1	INC DCN IS102-35-4 PER DCR 01-1685	SBV	
2	INC DCN IS102-35-2 PER DCR 00-1786		"INITIALS ON FILE"
3	INC DCN IS102-35-1 FOR DCR 91-001		"INITIALS ON FILE"
4	ISSUED FOR SECOND TO YEAR ISI PROGRAM		"INITIALS ON FILE"
REV.	DATE	REVISIONS	BY
DATE	DESIGNED BY	DATE	BY
DAVIS-BESSE NUCLEAR POWER STATION UNIT NO. 1			
INSERVICE INSPECTION DIAGRAM SPENT FUEL POOL COOLING SYSTEM			
IS102-035			5

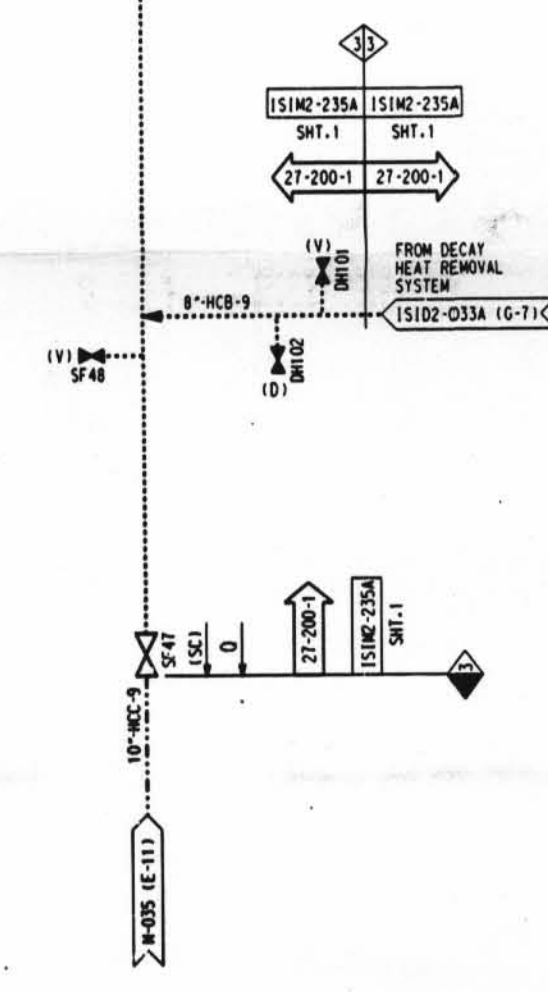
INFO. NOTE:
 (REMOVE AT NEXT UPDATE)
 REVISION CHANGE IN THE CLOUDED
 AREA WAS FOR COLORIZING THE
 SPENT FUEL POOL AS GREEN
